Technical Service Bulletin Notification TSB #17-011

TECHNICAL SERVICE BULLETIN

TSB# 17-011

The mounting bracket for the leveling system hydraulic pump requires reinforcement.

FIG 8: Place the new kit bracket between the support bracket (A) and the silver pump bracket (B). The Kit bracket will sit flush on top of the support bracket (A).

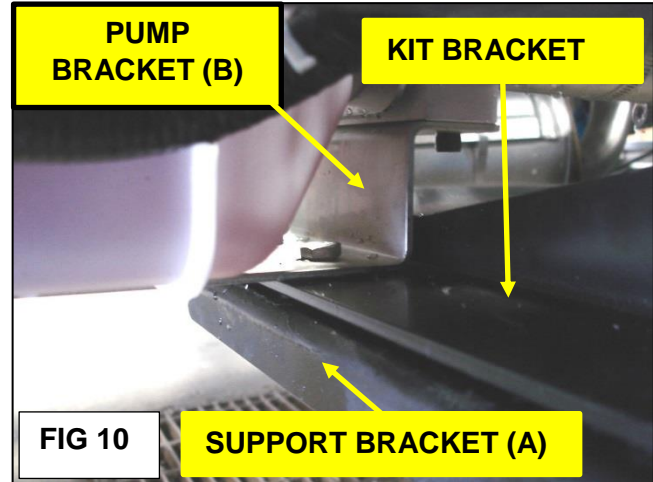
The tab on the end of the Kit bracket fits around the end of the support bracket (A).

FIG 10: The Kit bracket is sandwiched between the support bracket (**A**) and the pump bracket (**B**). The Kit bracket should be sitting flush on top of support bracket (**A**).

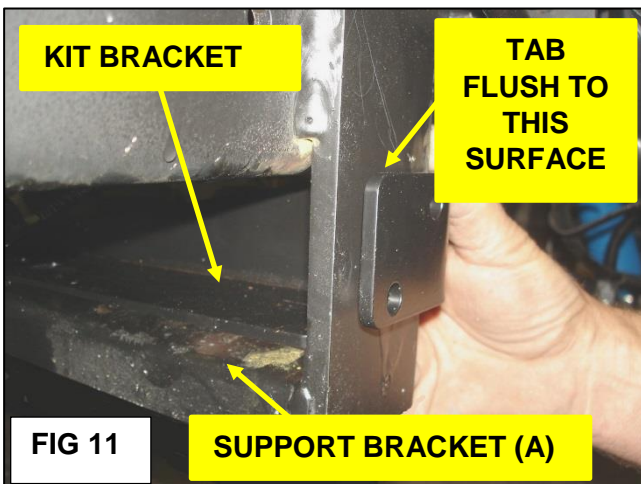
The 3/8" x 1" bolts go through **all 3 brackets** and are secured with the 3/8" nuts and lock washers removed in Step 1.

Leave the bolts loose temporarily until the Kit bracket is positioned properly.

FIG 11: Kit bracket should be flush on top of support bracket (**A**)

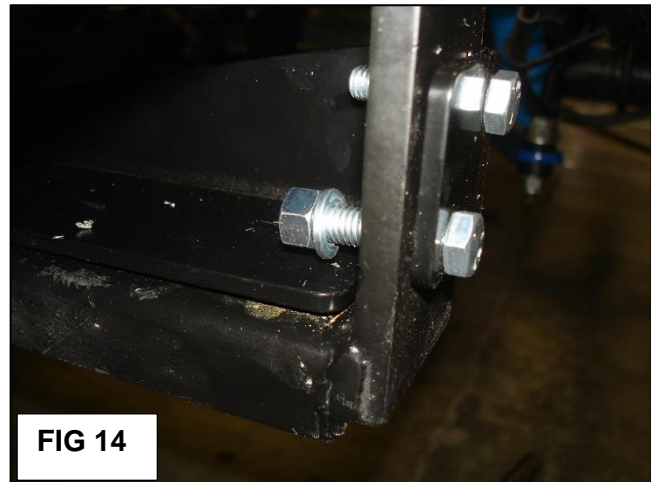
The tab on the end of the Kit bracket should be flush to the vertical surface of the support bracket (**A**). Tighten the two nuts underneath the support bracket (**A**).
